City of Palo Alto

City Council Staff Report

Summary Title: Connecting Palo Alto: Project Update and Possible Action on Rail Grade Separation Alternatives

Subject: "New Ideas" from XCAP Technical Working Group

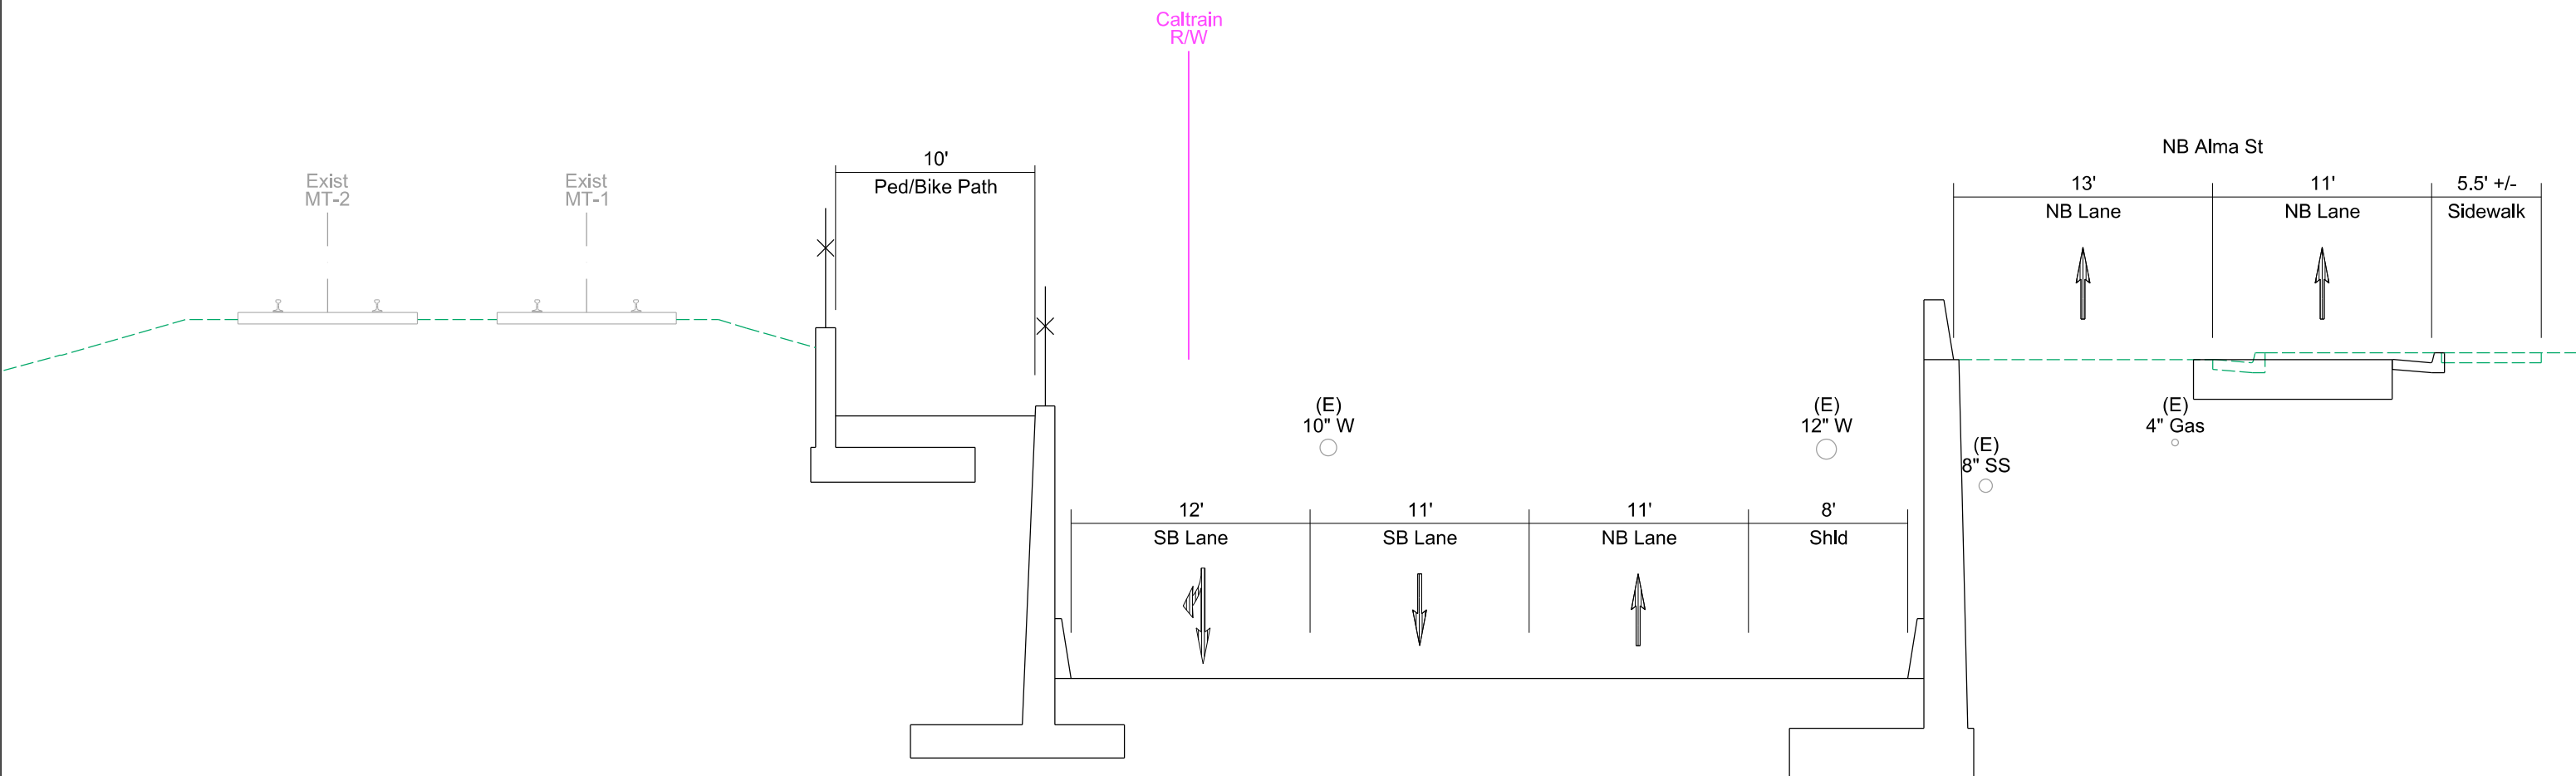
- A circuitous route is proposed for EB vehicles on Charleston and Meadow.
- Traffic on NB and SB Alma St destined for El Camino Real and other locations on the west side of the tracks would also have to traverse a circuitous route. In the NB direction, drivers will likely opt for Ely Pl to access Charleston via Mumford Pl to avoid any backups on Alma St, thus generating more traffic on residential streets.
- Road geometry would have to be hashed out to ensure queuing of vehicles (for the u-turn movement, for example) does not impact through movements.

Structure over Alma/Churchill

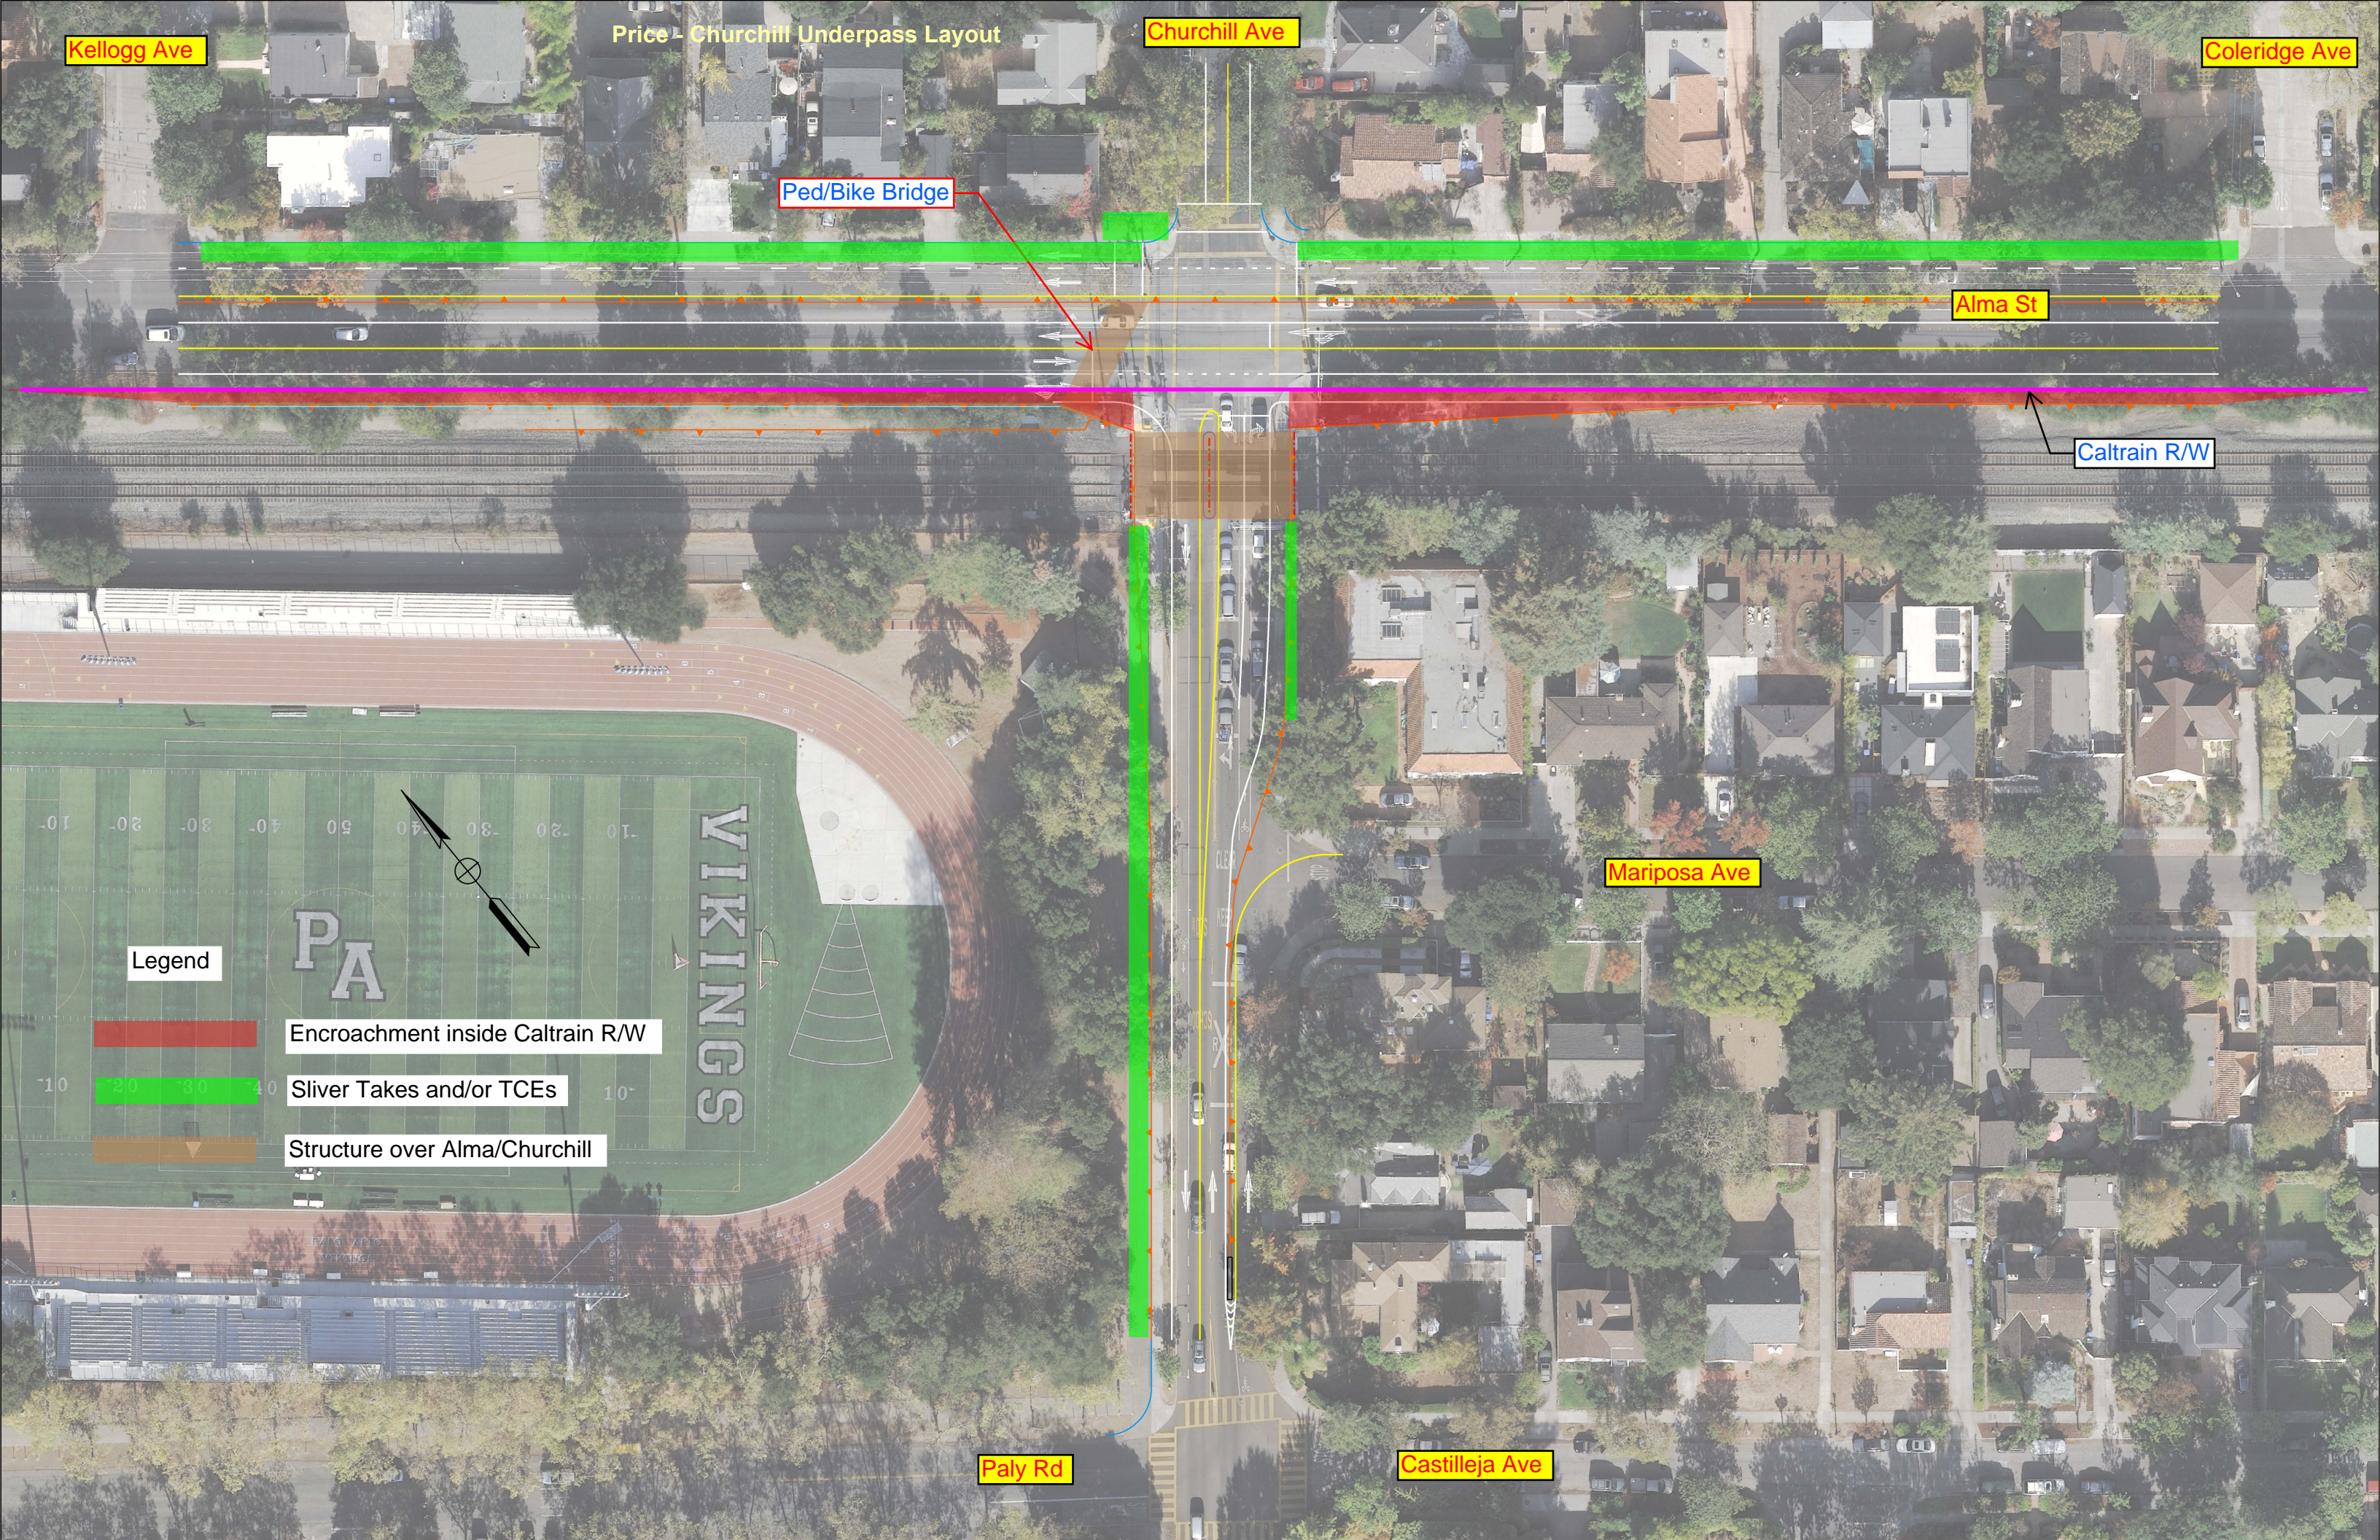
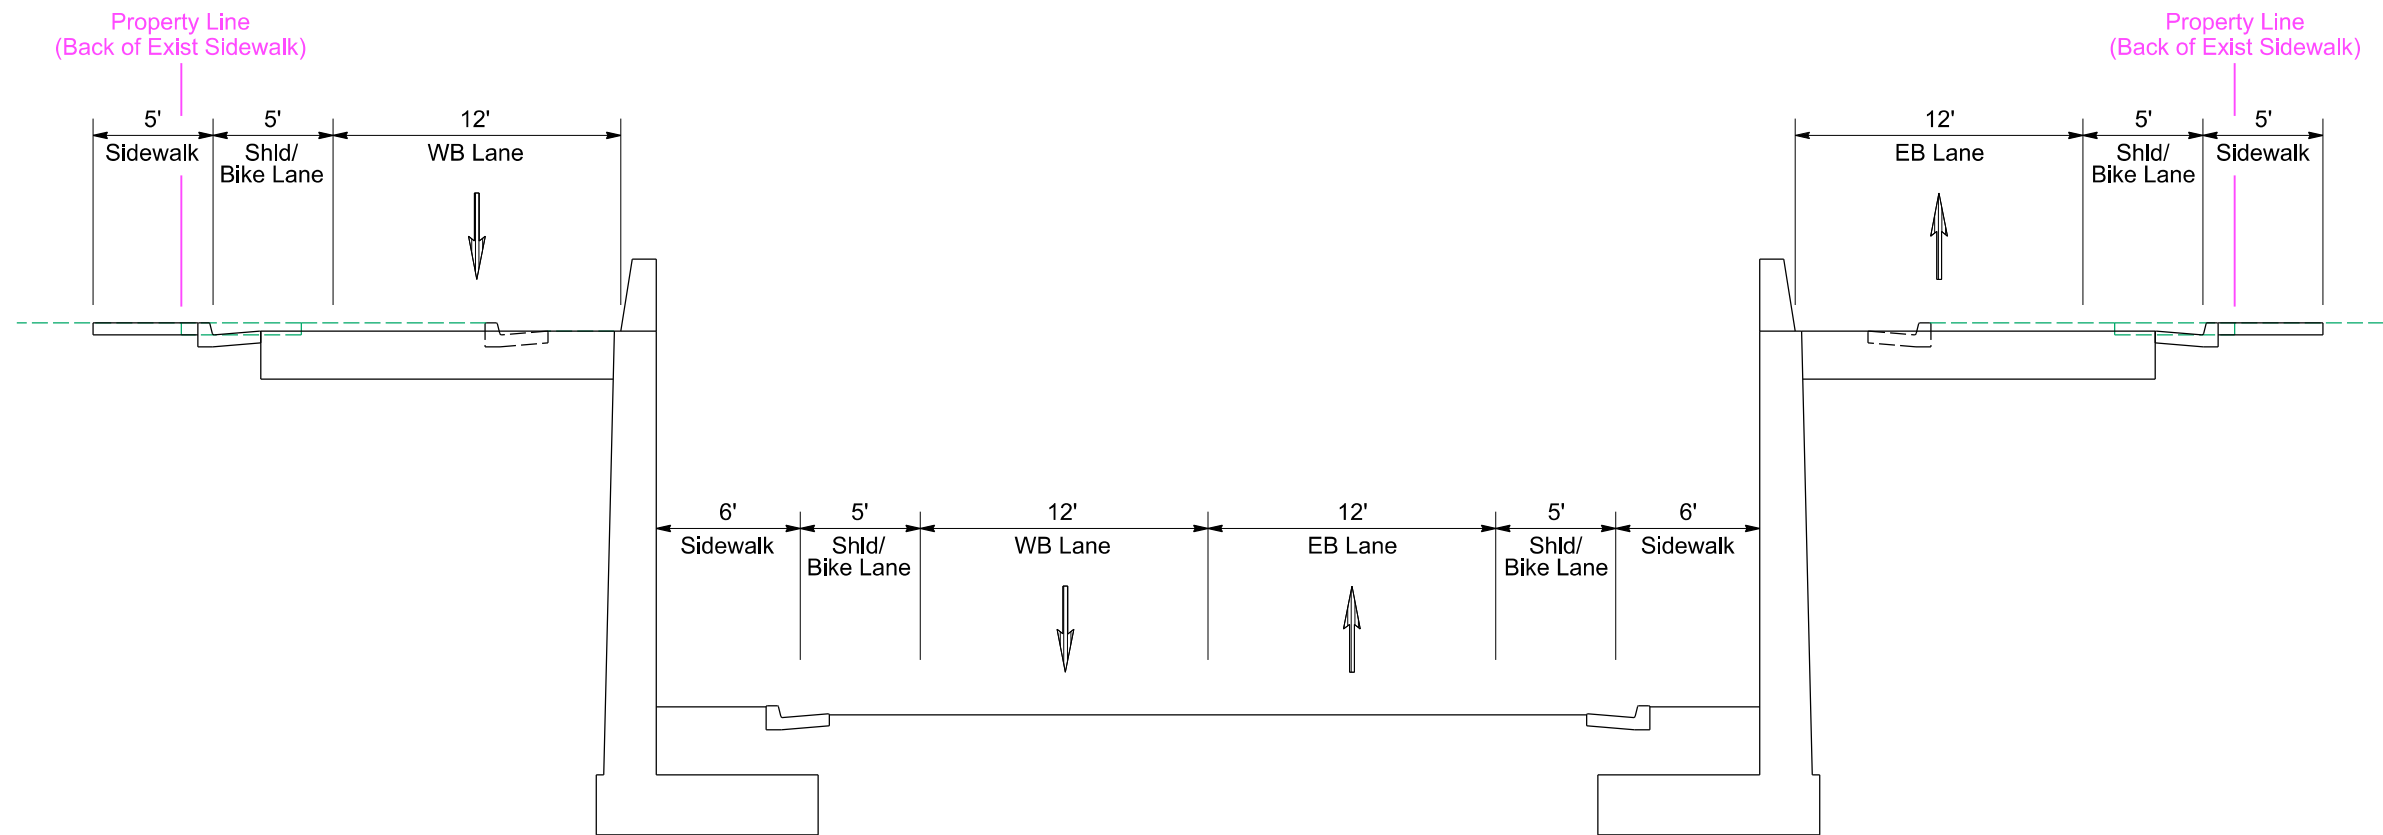
Geometrics/Structures

- The “split” of the roadway on NB Alma and EB Churchill introduces a fixed object in the road (end of the retaining wall), but we should be able to design this so that it’s not a safety hazard.

- The retaining walls on Alma will be tall (~20 feet Max) and will have a tunnel-effect. Providing left and right shoulders would be ideal, especially 8 to 10-foot right shoulders for disabled vehicles. To provide an 8-foot right shoulder on NB Alma St (connecting to Churchill Ave in the underpass), the landscaping strip on the east side of Alma St will have to be removed. This will reduce the setback distance from the curb line for many homes fronting Alma by approximately 9.5 feet.

- Need to evaluate a profile on Churchill to see if there’s an impact to the Churchill/Paly/Castilleja intersection. At first glance, it appears we can avoid lowering this intersection.

- Since there are no ped/bikes on Alma and Churchill (under the tracks), we can be more aggressive with the road profile and use 10-12% Max. This will help reduce the construction limits and cost.

- The bridge geometry and lane configurations need to be hashed out. We’ll need two through lanes on NB Alma.
- The sight distance at the T-intersection of Churchill and Alma will be less-than-standard for vehicles making rights/lefts onto Alma from EB Churchill. This is mainly due to very little space available for a right shoulder on SB Alma.

- Temporary Construction Easements (TCEs) will be required.
- Full acquisitions likely not required, but partial/sliver residential takes potentially needed along Alma St and potentially a home on the east side of Mariposa Ave.
- Curb setback distances must be reduced for homes along Alma St, as noted above.
- Potential minor relocation of the ped/bike trail on the north side of Churchill (between Castilleja Ave and the railroad).
- The far-right lane on SB Alma St will encroach inside Caltrain’s R/W. This will have to be reviewed/approved by Caltrain.

- Pump Station will be needed to drain the lowered Churchill/Alma intersection.
